UNITED STATES
DEPARTMENT OF THE INTERIOR
BUREAU OF LAND MANAGEMENTCarlsbad Field Office
OCD ArtesiaFORM APPROVED
OMB NO. 1004-0135
Expires: July 31, 2010**SUNDRY NOTICES AND REPORTS ON WELLS**
*Do not use this form for proposals to drill or to re-enter an abandoned well. Use form 3160-3 (APD) for such proposals.***SUBMIT IN TRIPLICATE - Other instructions on reverse side.**

OXY USA INC respectfully request permission to add additional equipment to the above mentioned location. The additional equipment is as follows:

FNR 26 FED #1 CTB

FAC LAYOUT - PHASE I

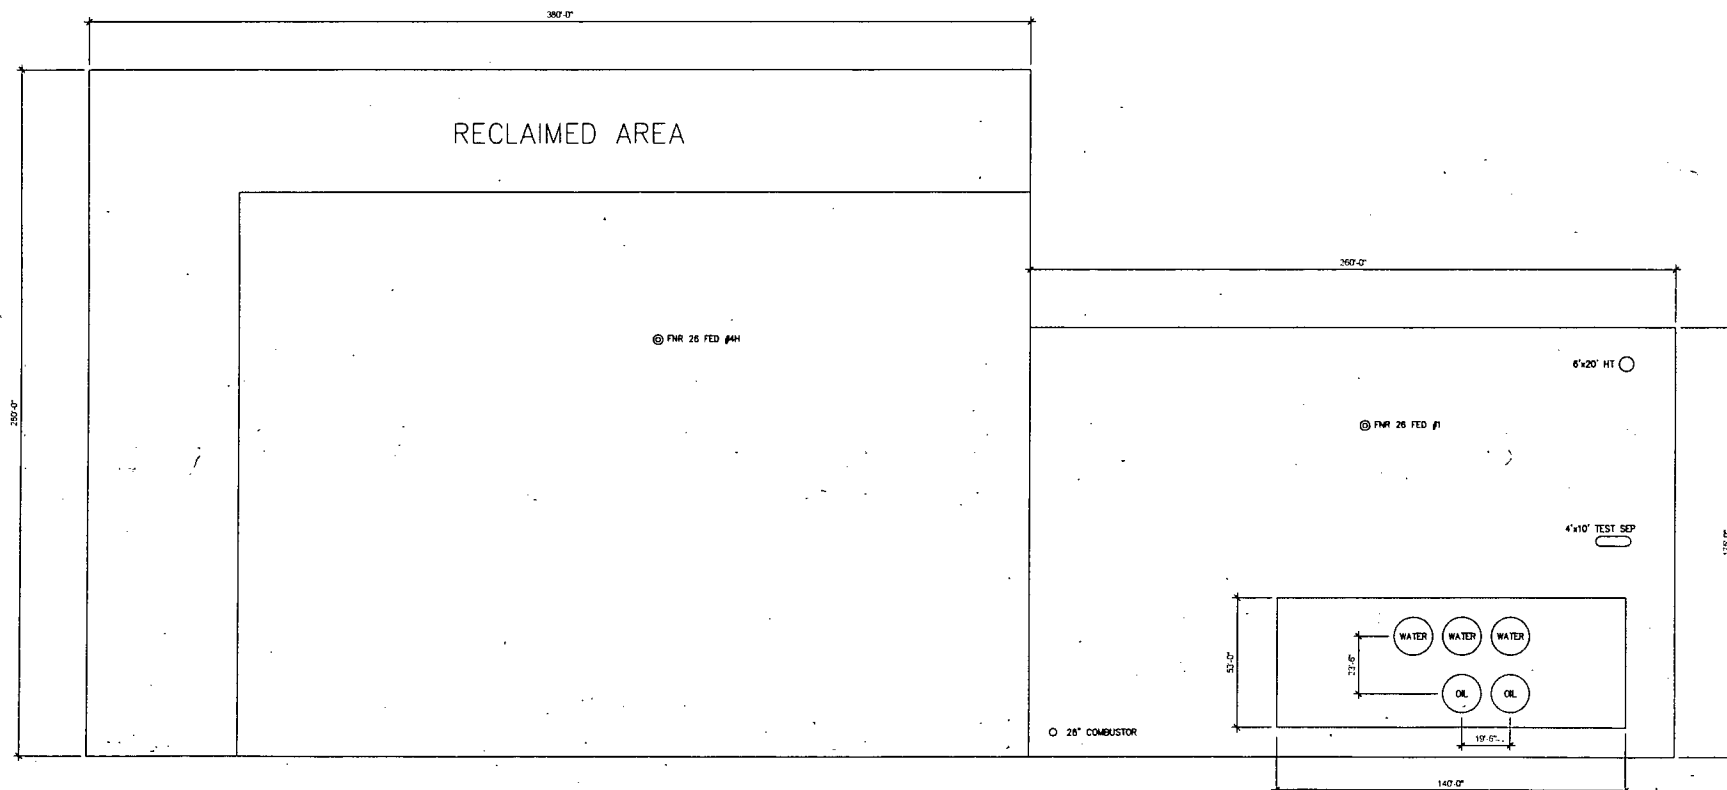
- 1) INSTALL TWO (2) 500 BBL OIL TANKS
- 2) INSTALL THREE (3) 500 BBL WATER TANKS
- 3) INSTALL ONE (1) 6'X20' HEATER TREATER
- 4) INSTALL ONE (1) 4'X10' 3-PHASE SEPARATOR

FAC LAYOUT - PHASE II

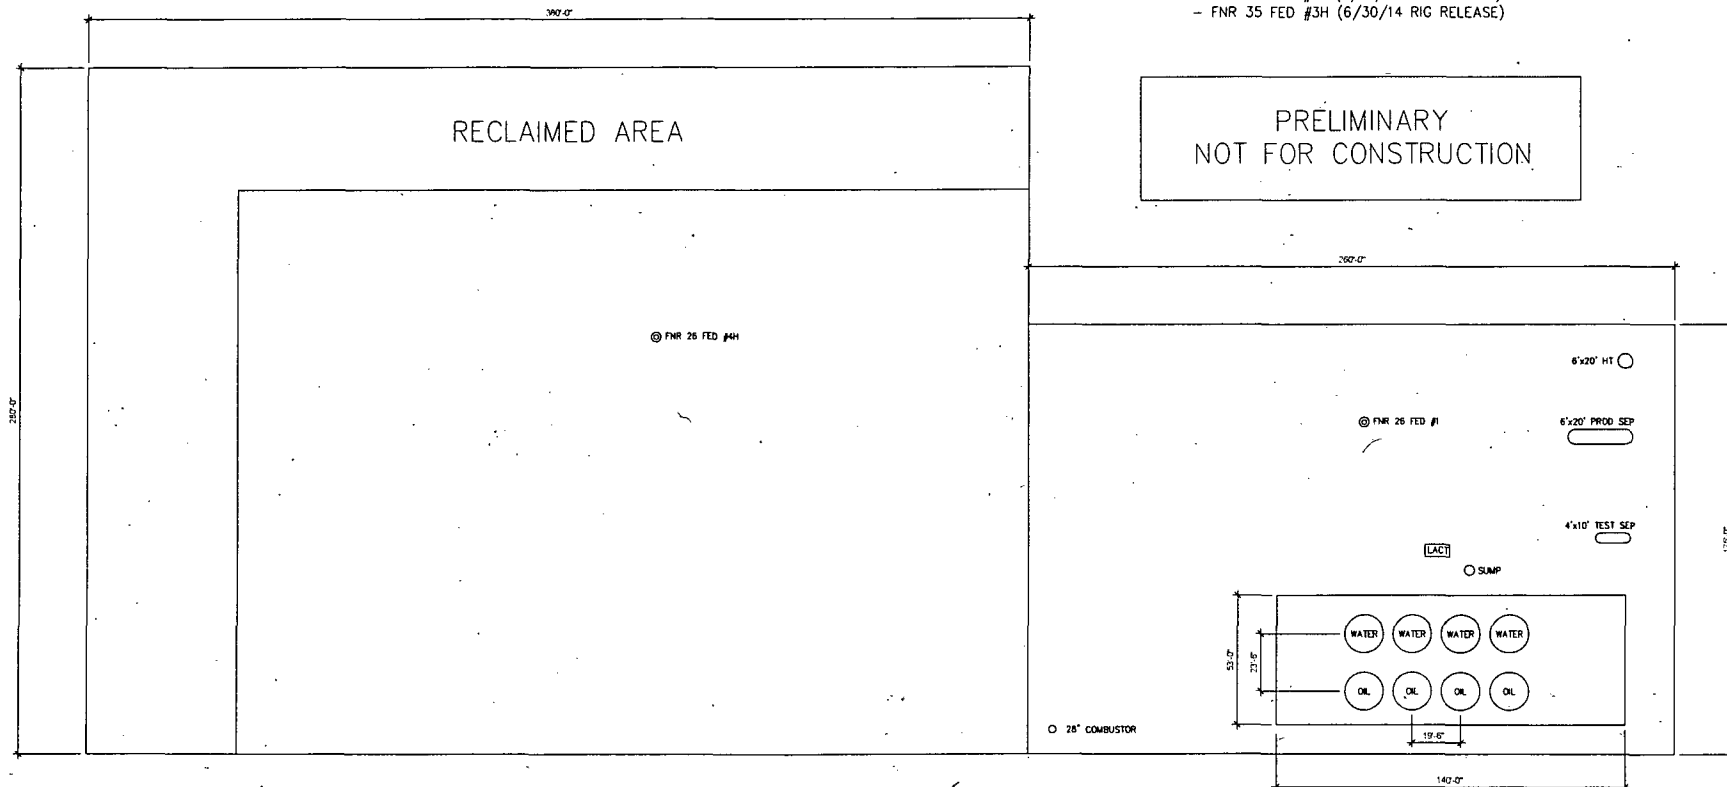
- 1) INSTALL ONE (1) 500 BBL WATER TANKS
- 2) INSTALL TWO (2) 500 BBL OIL TANK
- 3) INSTALL ONE (1) 6'X20' 3-PHASE TEST SEPARATOR
- 4) INSTALL ONE (1) TRUCK LACT UNIT
